Docket Number:	08-AFC-08A
Project Title:	Hydrogen Energy Center Application for Certification Amendment
TN #:	200300
Document Title:	BVWSD's Response to CEC Data Request and PSA
Description:	N/A
Filer:	Tiffani Winter
Organization:	Buena Vista Water Storage District
Submitter Role:	Public Agency
Submission Date:	8/21/2013 2:34:30 PM
Docketed Date:	8/21/2013

RE: Response to CEC Data Request dated March 21, 2013
Response to Preliminary Staff Assessment dated June 28, 2013

Response to CEC Data Request of 21 March, 2013.

Attachment 1.

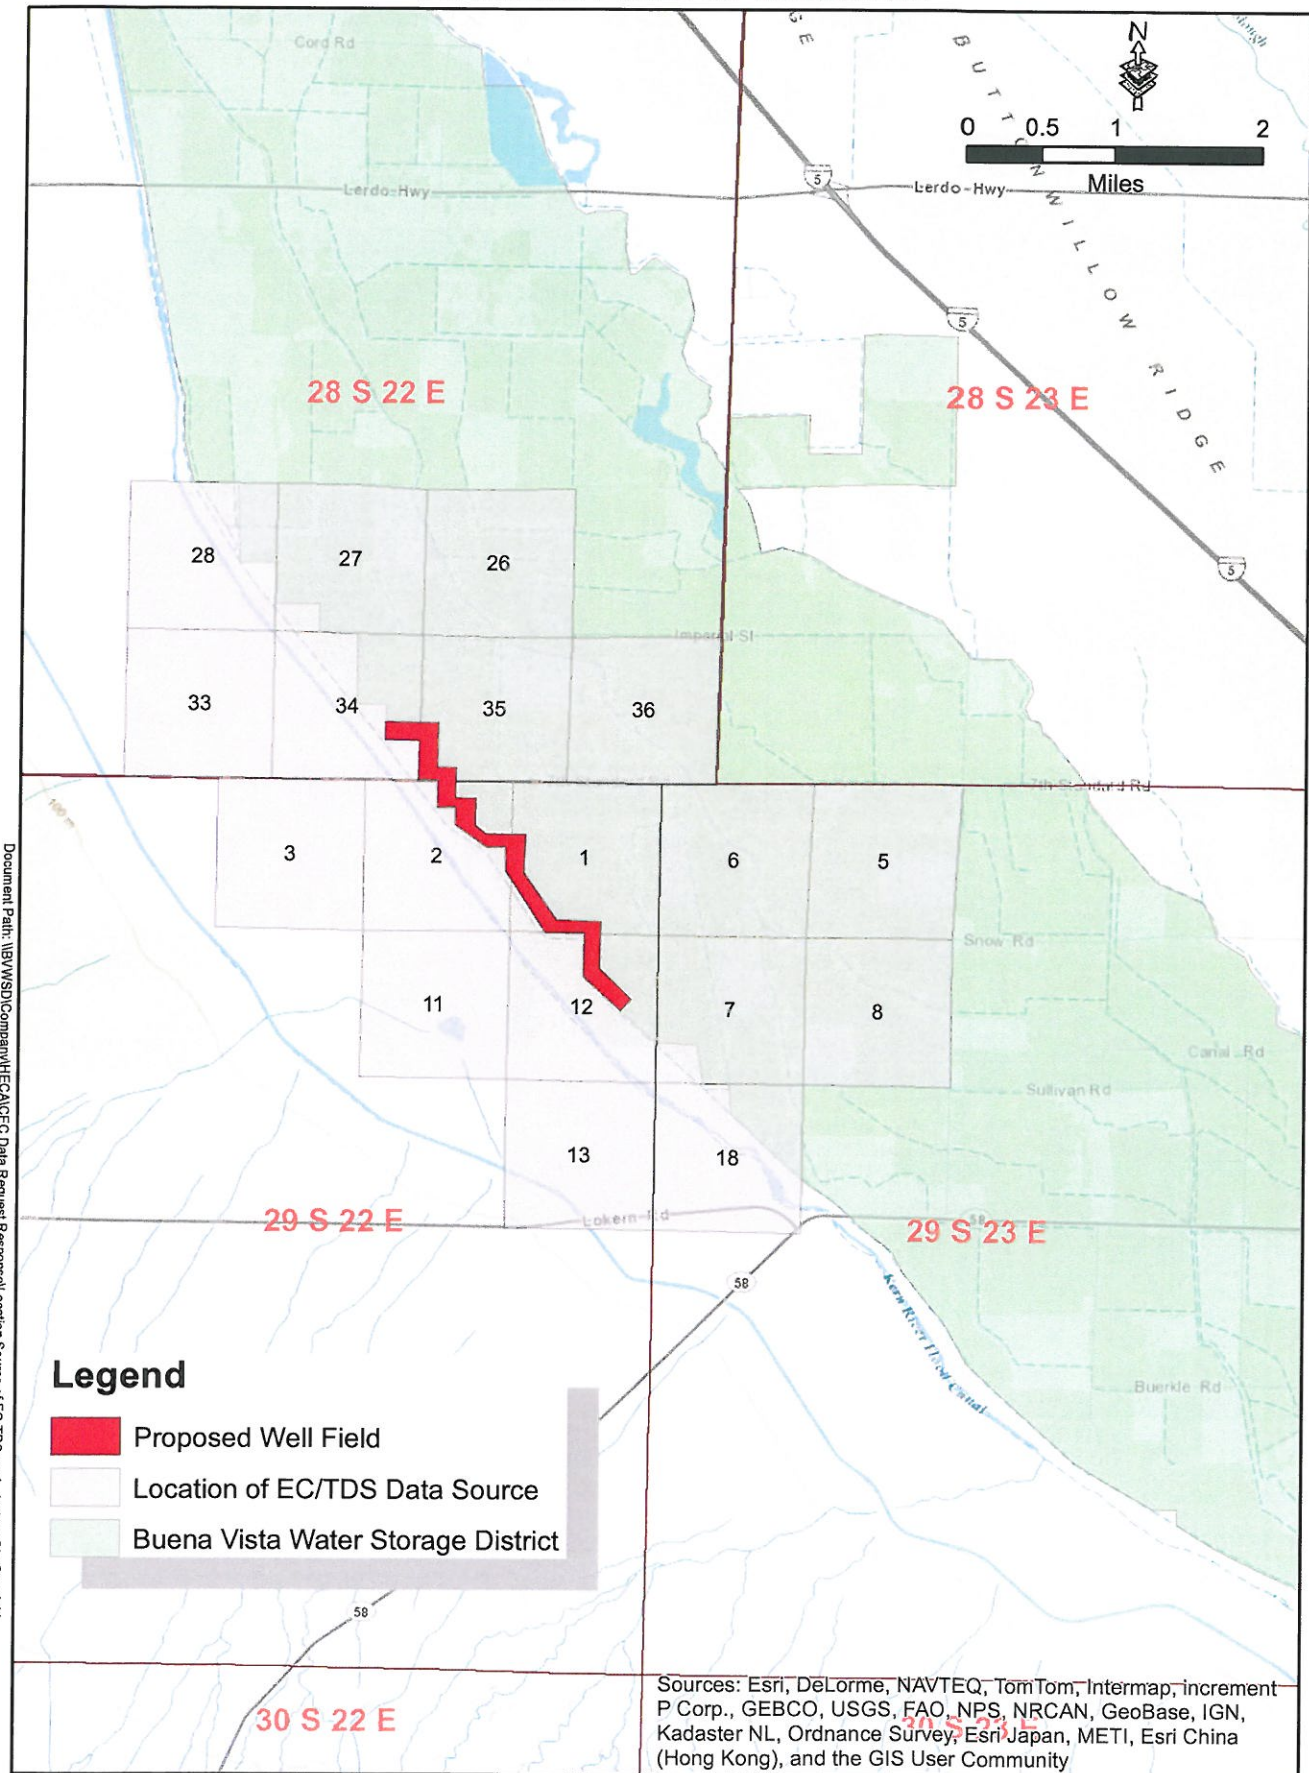
CEC DR 1. Please provide all water quality data from within the potential zone of influence (or within two miles) of the proposed HECA project pumping wells.

- Table 1. CEC- EC & TDS data1.xls
- Attachment 1: Potential Zone of Influence

Attachment 1 shows CEC- EC & TDS data1.xls data coverage which includes sections from four township areas centered on the proposed well field (28s/22-23e, 29s/22-23e). Table 1 includes 285 records, including 284 records of EC and 24 records of TDS, from 77 wells.
